TITLE	TITLE PAGE	DA
PROJECT	NEW RESIDENCE	
ADDRESS	28 DONNELLY ST PUTNEY	
CLIENT	S & L CHAN	
SCALE	Refer to scale bar	
DATE	JULY 2022	A00
		A

Approved Plans
LDA No. LDA2022/0035
Date: 31 August 2022
Council Officer: Jane Tompsett
Subject to Conditions of Consent

DRIVEWAY SECTION

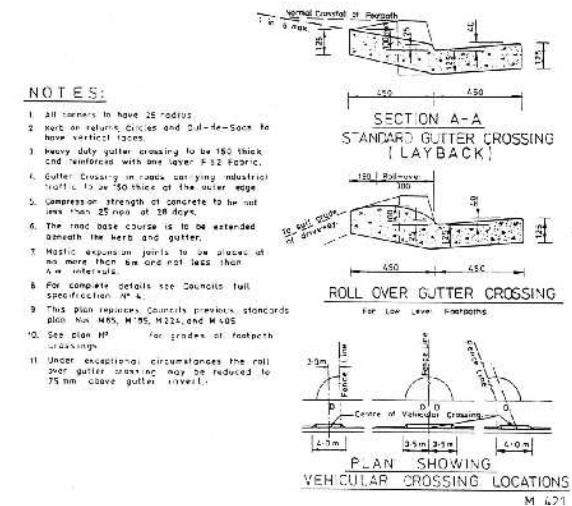
The proposed grade appears to be erroneous. The driveway profile shall be updated to reflect the proposed levels on the driveway ramp and in accordance with AS2890.1.2004.
